STATION SYSTEMS - POWER SUPPLY

INSTALLATION AND MAINTENANCE

- This addendum supplements Section C70.026. It is issued to add voltage requirement information when associating 1A KTS with a 555 PBX. It also covers general information and some restrictions for equipment installed in the city of San Francisco.

Fig. 1A

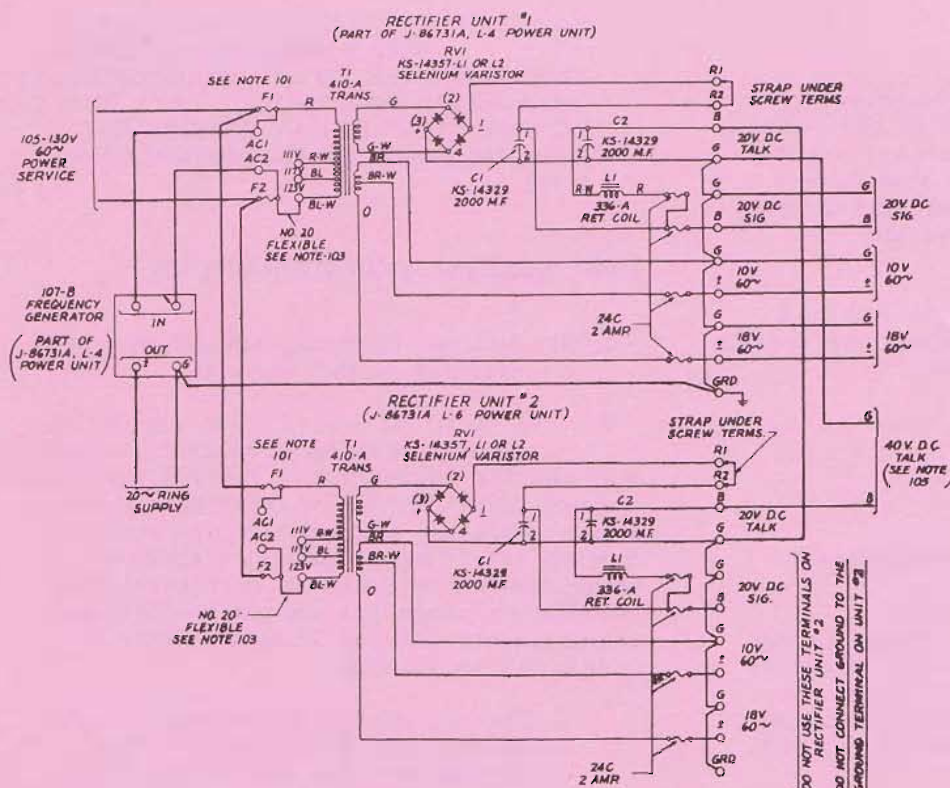
- Whenever additional voltage is required to operate 1A key telephone systems (50 type KTU, 1A KTU but not 1B KTU) associated with 555 PBX equipment, arrangements as shown in Fig. 1A (Dwg. H3075) may be used.

- 101 FUSES (F1) AND (F2) SHOULD BE MDL 2 FUSETRONS
- 102 LEADS NOT FURNISHED WITH APPARATUS SHOULD BE 20 AWG SOLID.
- 103 THE TAP ON THE PRIMARY OF THE POWER TRANSFORMER SHOULD BE CONNECTED TO A TERMINAL WHICH WILL LIMIT THE TALKING BATTERY OUTPUT TO A MAXIMUM OF 50 VOLTS.
- 104 REPLACE THE K2 LAMPS WITH 2Y LAMPS WHEN THIS RECTIFIER ARRANGEMENT IS USED.
- 105 WHEN THIS ARRANGEMENT IS USED WITH ONE POSITION OF 555 PBX, REPLACE THE 2 AMP 24C FUSES IN THE 20V TALK CIRCUITS WITH 1 1/2 AMP 24G FUSES. WHEN USED WITH TWO POSITIONS OF 555 PBX, LEAVE THE 2 AMP FUSES IN PLACE IN THE RECTIFIER, BUT FUSE THE BATTERY SUPPLY LEADS TO EACH POSITION WITH 1 1/2 AMP FUSES.
